APPENDIX 3

COMMENTS RECEIVED AFTER CLOSE OF PUBLIC COMMENT PERIOD

Re: Windham Mountain Sporting Club

SEQRA Comments of the Watershed Inspector General to the Town of Windham
Planning Board Concerning the Proposed Windham Mountain Sporting Club

Figure 1

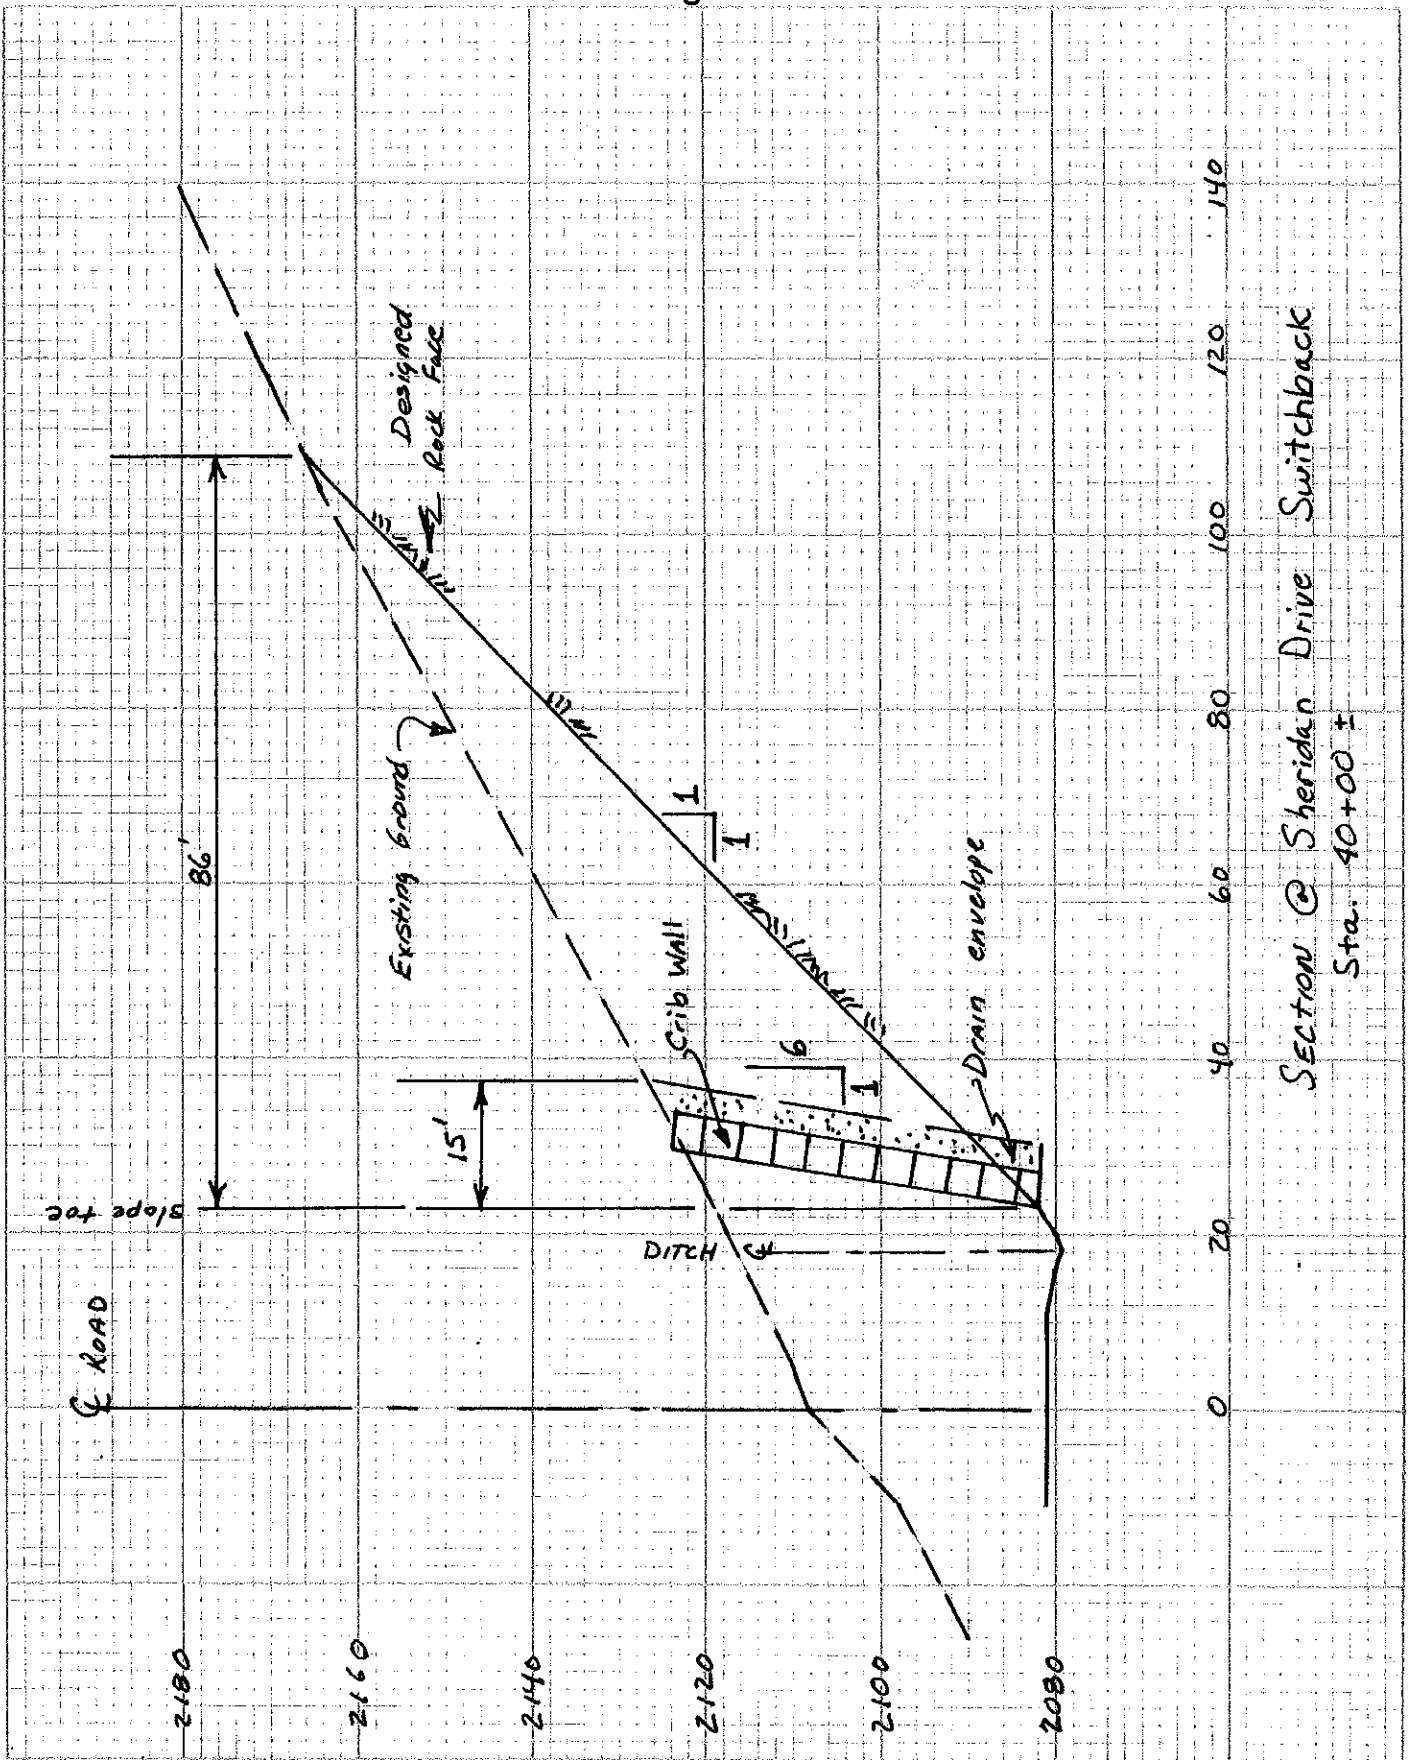
structured wall.⁷ Attached as Figure 1 is a cross-section drawing of Sheridan Drive at road Station 40+00 at the maximum cut of the proposed switchback for that road. It shows the extreme difference between height and lateral disturbance for 1:1 rock slope versus the 1:6 structural units proposed.

Figure 6.19 Bioretention (F-5)

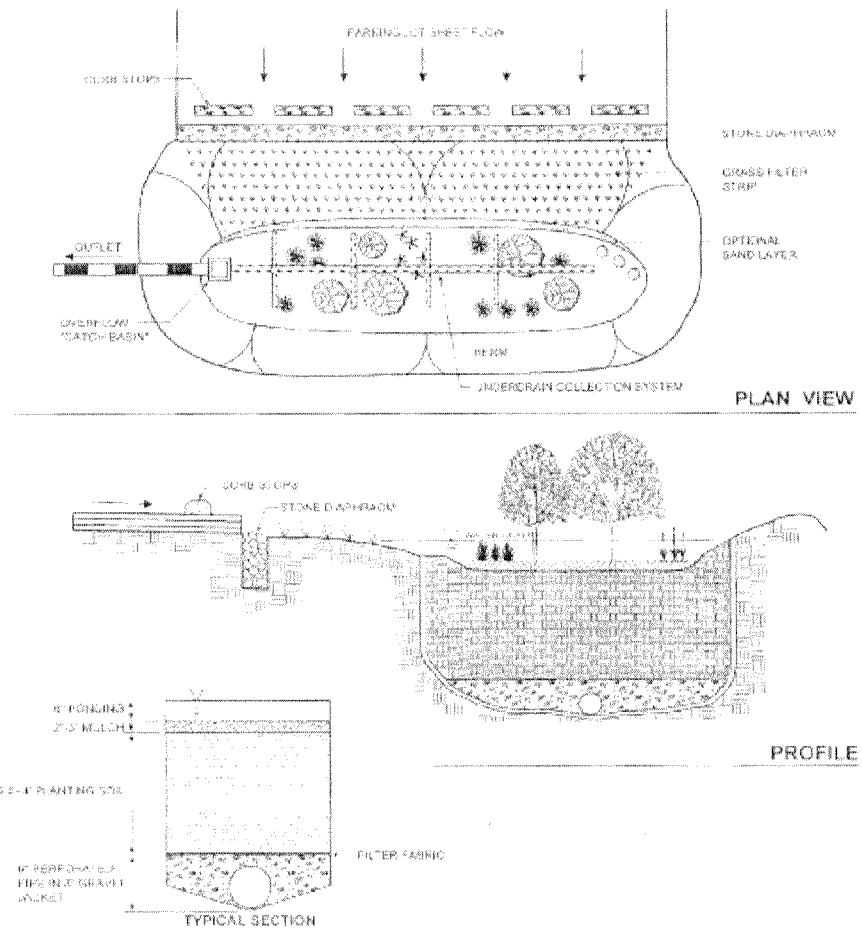
3. Attached are a figure and table from the New York State Stormwater Management Design Manual, August 2010, that show the typical configuration and physical feasibility parameters required for bioretention practices. Although the response from the LA Group shows that there is spatial room to construct this practice on these lots, additional criteria must be met. The depth to the groundwater table and maximum ground slope of 6% have not been verified as having been met. Since this practice is critical for runoff reduction on this site, and has been shown by www.bmpdatabase.org to have an average total phosphorus (TP) removal of 18%, these criteria must be investigated and the results submitted to the NYSDEC for approval.
